BEFORE THE PUBLIC UTILITY COMMISSION

Docket No. LC 73

2019 Integrated Resource Plan.

Staff Final Comments

Figure 2: E3 Market Capacity Assumptions Used to Model Capacity Need:¹⁵

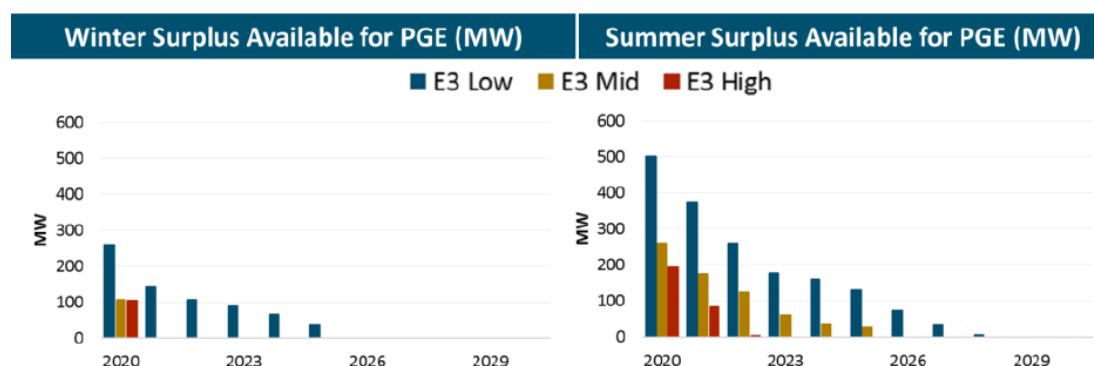
Staff plans to recommend an IRP acknowledgement condition that PGE monitor and report on this key assumption as part of any RFP and in the 2021 update to LC 73, as market conditions may encourage the building of more generation resources regionally.

Figure 5: NREL Battery Cost Projections³²

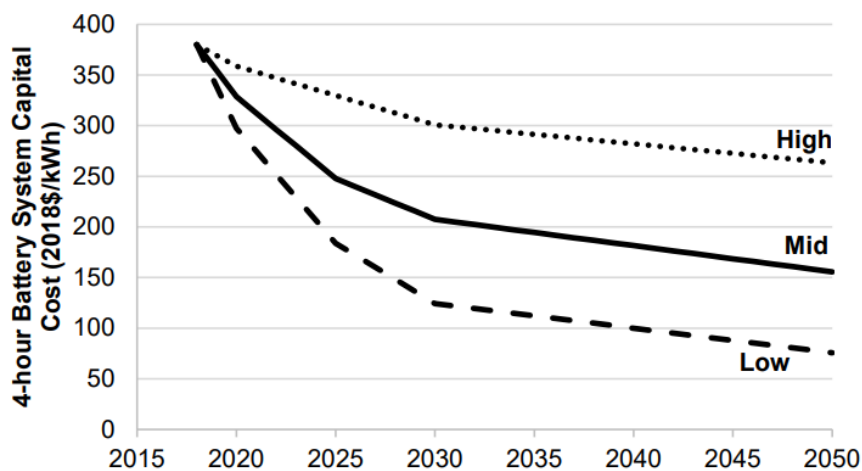
Staff agrees that battery technology is likely to improve rapidly. In the time since PGE’s 2019 IRP was filed, it has become apparent that battery costs are falling more rapidly than PGE’s modeling assumptions have anticipated. A recent NREL paper published in 2019 shows that the mid-range of published storage cost projections expect battery storage costs to fall steeply from 2019 through 2021, and then fall an additional ~23% from 2021 through 2026. Even the high cost NREL scenario shows costs falling approximately 7% from 2021 to 2026.³¹ This is compared to PGE’s assumptions that battery costs fall less than 10% in the reference case from 2021 to 2026.

Figure 9: PGE's Renewable Glide Path for the Preferred Portfolio⁷²

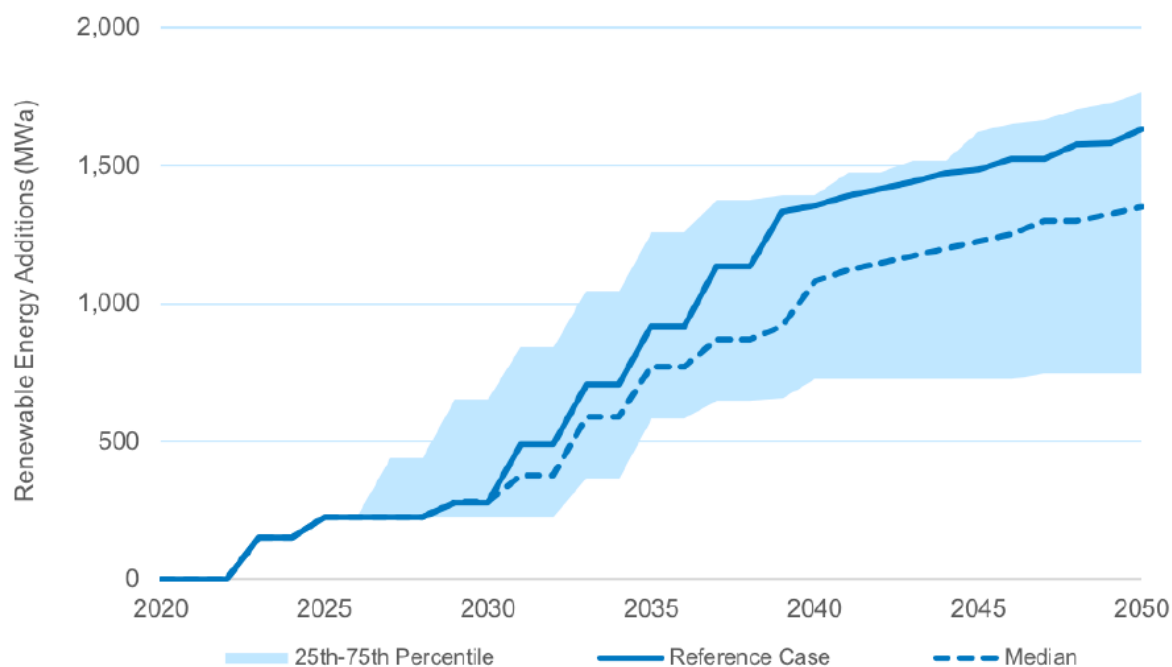
Without additional explanation, Staff finds it difficult to find a concrete justification for why the Renewable Action is the appropriate size. Staff cannot recommend acknowledgement of this item until presented with an approach that aligns more clearly with the IRP’s cost and risk assessment.

Figure 11: Navigant Study Summer Peak Demand Reduction Forecast⁹⁵

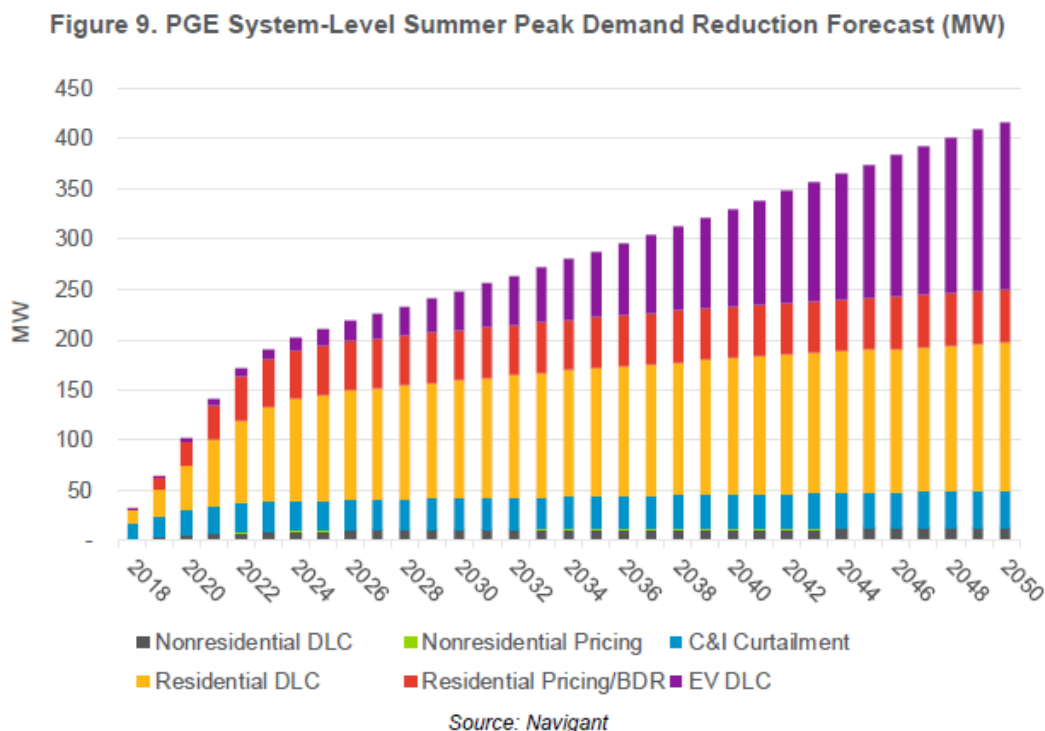
Staff appreciates the growth embodied in the forecast above. However, it falls short of expectations of growth for DR and may signal a troubling turn in PGE's commitment to DR from the 2016 IRP. The potential shown above is (a) well below a national benchmark average for peak impact from DR, and (b) marks a large decrease from the DR potential found in the previous IRP. First, 2017 research from ACEEE found that most utilities, on average, can reduce peak demand by approximately 10 percent. PGE's 2024 forecast for DR is approximately 6 percent of forecasted peak. Second, the Brattle Group study used in PGE's previous IRP identified between 261 - 278 MW of cost-effective, 2021 summer-peak DR from only direct load control programs (DLC) without any customer program crossover. The graphic above shows PGE achieving less than one-half of that amount of DLC by 2025.
